92-5

REQUIRED WARNING DECAL INSTALLATION

Models Affected

71229

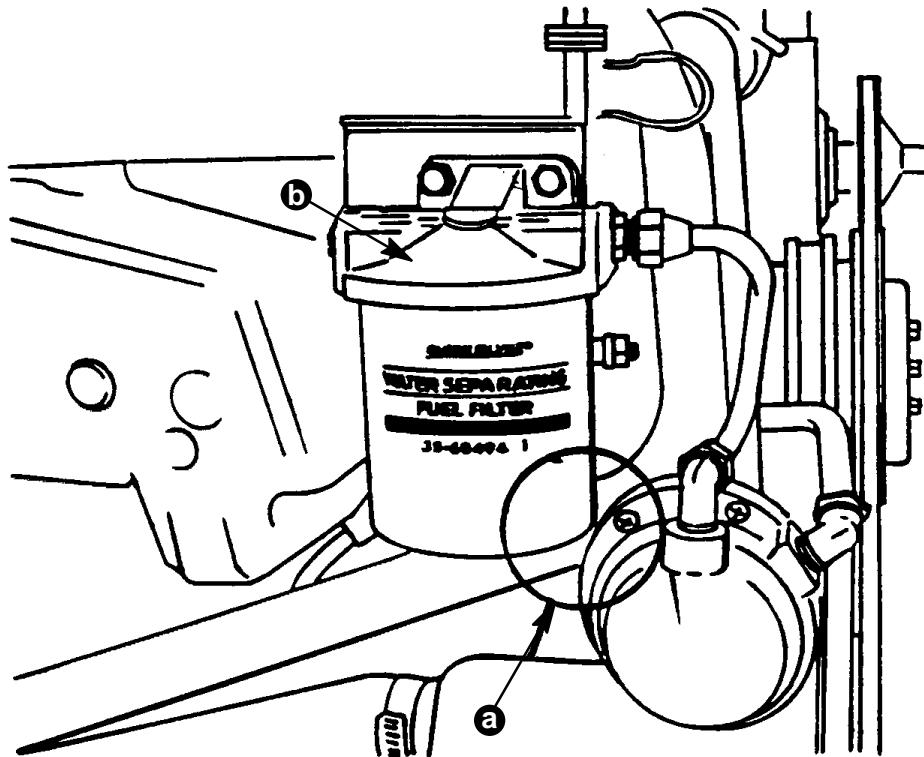
If too long of a fuel filter is installed on these engines, it could come in contact with the fuel pump. After a period of time, a hole will be worn into the bottom of the filter (a) which in turn will allow fuel (gasoline) to leak into the bilge of the boat.

a - Filter may wear through in this area
b - Dealer to place warning decal here

Look for WARNING decal on Fuel Filter Base Assembly at location (b) as shown in the drawing. If the decal isn't there, one must be installed.

Install the WARNING decal on any engine you have in stock. If the boat has been sold, please contact your customer and perform this service on his engine(s). Also, please make sure that the short filter P/N 35-805269--1 has been installed as outlined in Service Bulletin 91-27. When an engine is registered at Mercury Marine, our computer will check to see if the decal has been installed. If our records do not show that the decal was installed, the customer will be contacted by letter with a campaign card enclosed. Please install the decal, then use the campaign card to file for warranty.

- a - Filter may wear through in this area
- b - Dealer to place warning decal here

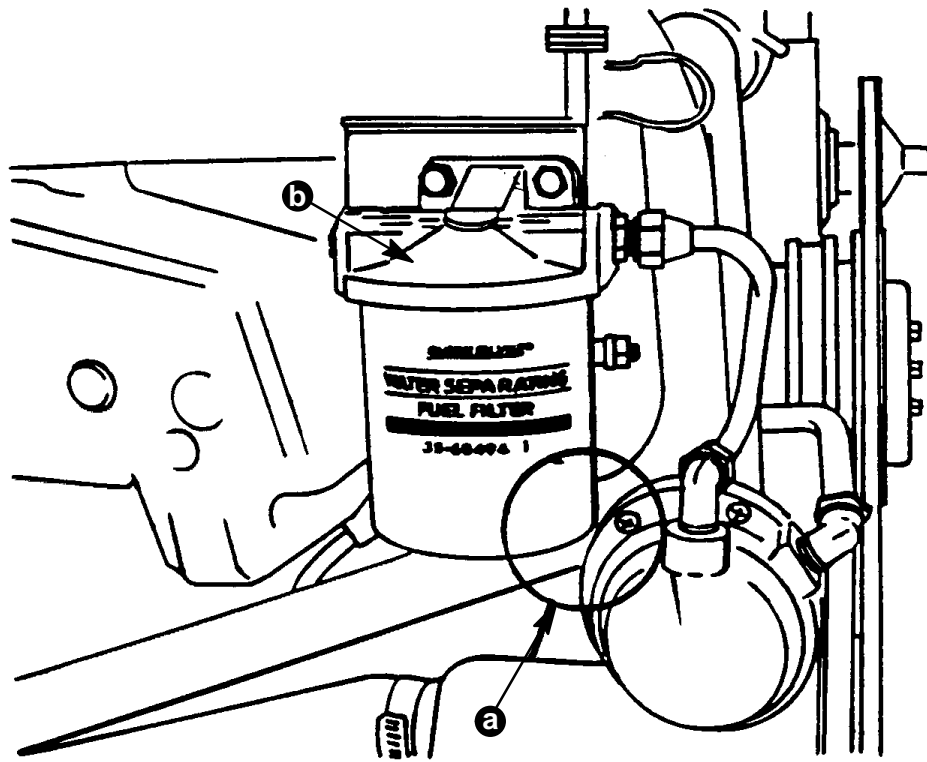
Because of the unique fuel pump arrangement on your engine, a special water separating fuel filter was developed. It is very important that when this filter is replaced in accordance with your Operations and Maintenance Manual, a Quicksilver filter 35-805269--1 or a filter with a maximum length of 3-3/4 inches (95 mm) is used.

If a filter longer than 3-3/4 inches (95 mm) is used, it is possible that the filter could contact the fuel pump. This contact could result in a hole being worn through the filter causing a fuel leak. A leak would create the potential for a fire or explosion if an ignition source is present.

Attached is an illustration of a warning decal. Part Number 37-805349. This decal should be applied to your engine by your MerCruiser dealer as a reminder that a special filter is required.
